From: Tom Gurdziel <tgurdziel@twcny.rr.com>
Sent: Saturday, December 10, 2016 8:16 AM
To: CHAIRMAN Resource
Cc: Screnci, Diane; ESTRONSKI@aol.com; T Holden; Lyon, Jill:(NMP); Bridget Frymire; Barkley, Richard
Subject: [External_Sender] Three Mile Island, Unit 2 Accident
Attachments: M.O. Bypass Valve.jpg

I have just finished reading the description of the Three Mile Island, Unit 2 accident in Section 2.1 of NUREG/CR-6042, Rev. 2. I am having some trouble with the explanation given in the paragraph at the top of page 2.1-2, left hand column.

Figure 2.1-3 Condensate and feedwater systems

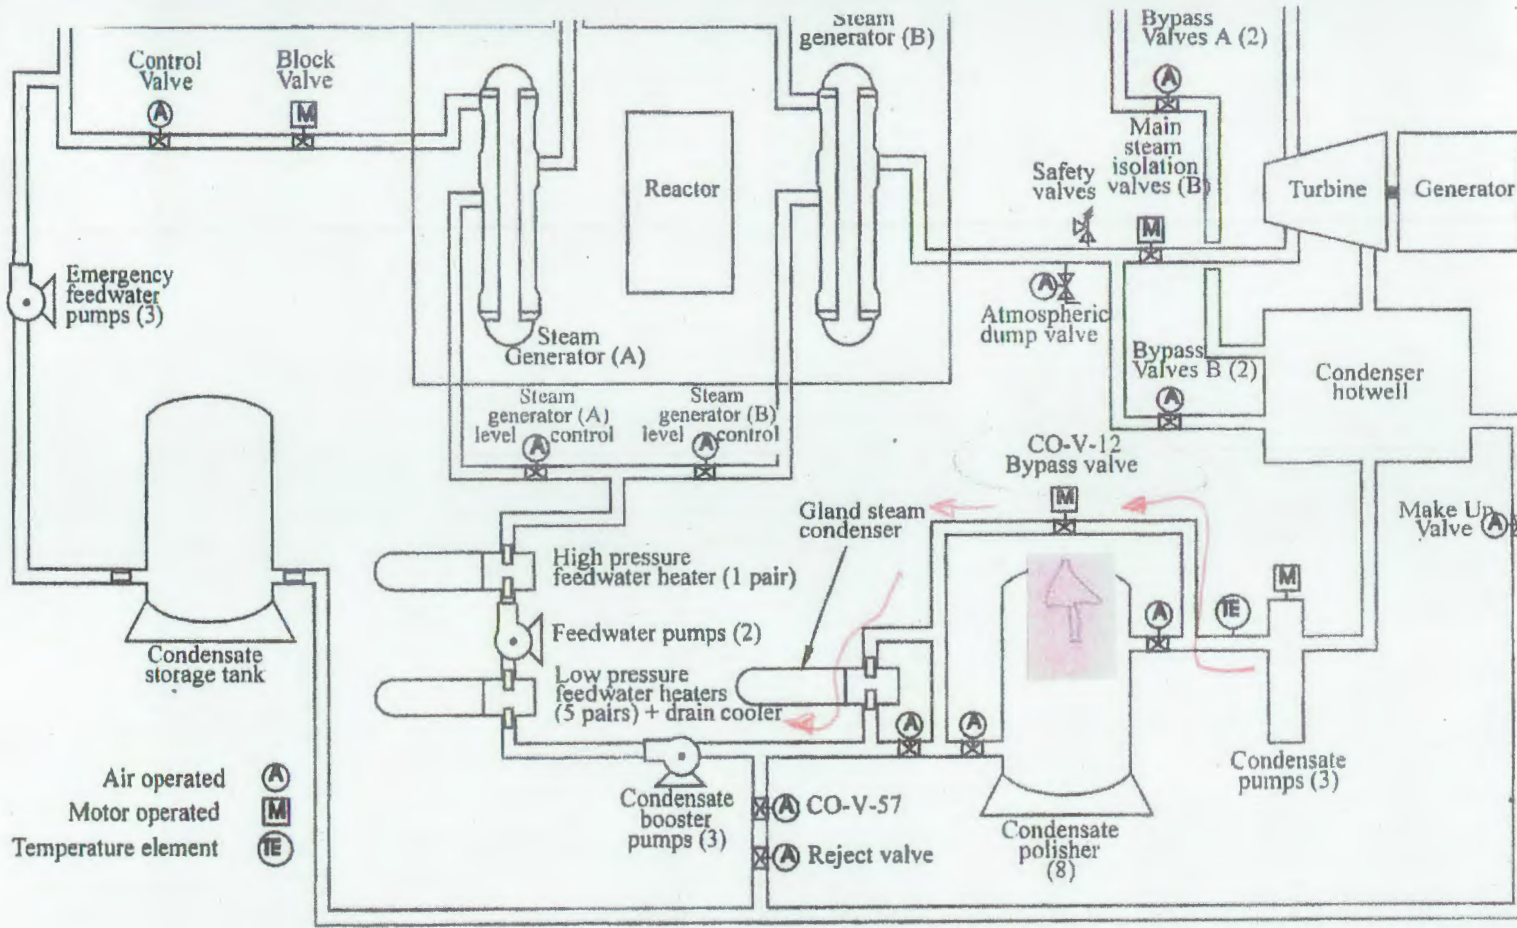
Looking at Figure 2.1-3 on page 2.1-27, (attached), there appears to be one action that might have restored condensate (water) flow: open demineralizer/condensate polisher bypass valve CO-V-12. Would this one action have been sufficient to prevent core destruction? (This valve is not air operated.)
